**SUBJECT: RECALL R09PY FMVSS 221 SCHOOL BUS BODY JOINT  
STRENGTH NONCOMPLIANCE-INCORRECT  
NUMBER OF RIVETS IN FRONT ROOF CAP**

## Front Roof Cap Joint Strength Noncompliance

**Models Affected:** 2008 through 2010 model Blue Bird **Micro Bird** school buses manufactured at Fort Valley, Georgia from July 22, 2007 through November 28, 2009

### CORRECTIVE ACTION

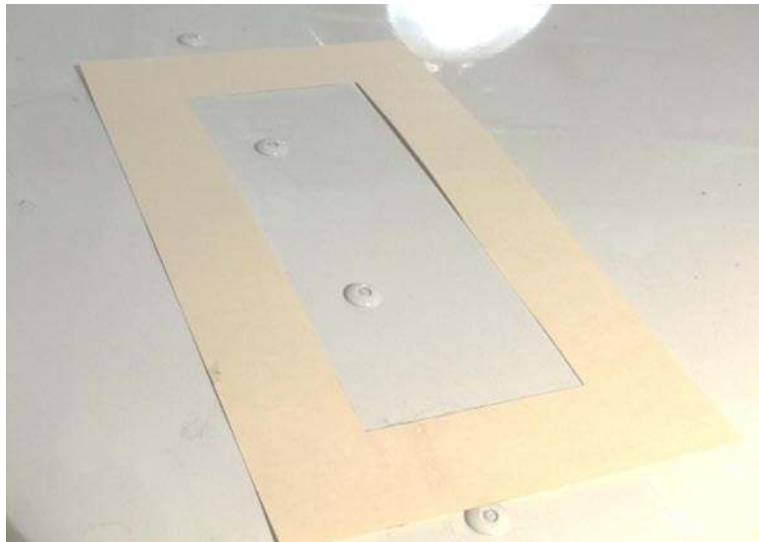
On some units, the incorrect amount of adhesive may have been used in some segments of the front roof sheet and front roof cap joint, resulting in noncompliance with FMVSS 221, School Bus Body Joint Strength.

1. Inspect rivet spacing at front roof cap and front roof sheet joint. Joint must have a minimum of four rivets in any eight inch segment.
2. Place the template over the front roof cap joint rivets and parallel to the edge of the front roof cap, allowing front roof cap rivets to be exposed through the opening as illustrated below.

Inspect the rivet spacing at the joint and install additional rivets as required by specification.

3. Move the template from one side of the front roof cap to the opposite side.
4. If a segment in the front roof cap joint contains less than four rivets, additional rivets are required. Mark each area that requires additional rivets.

5. If one rivet is required; add a rivet equally spaced between the two rivets with the largest space in this section.
6. If additional rivets are required; add additional rivets between the largest spaces until a minimum of four (4) rivets have been added in the eight (8) inch segment.
7. Install rivets at each mark. Using a **short** 17/64" drill bit, drill a hole through the roof cap, roof sheet, and bow flange. Be sure to drill hole on a common centerline with existing rivets.
8. Place a small amount of Vinyl Gray 5522 Sealant (Blue Bird #00898627) in each drilled hole.
9. Install 1/4" blind rivets (Blue Bird # 01854397) into each hole.
10. Clean up any sealant that may have squeezed out or smeared during rivet installation.
11. Using the correct color paint, touch up the center of each blind rivet where the stem was removed during installation.
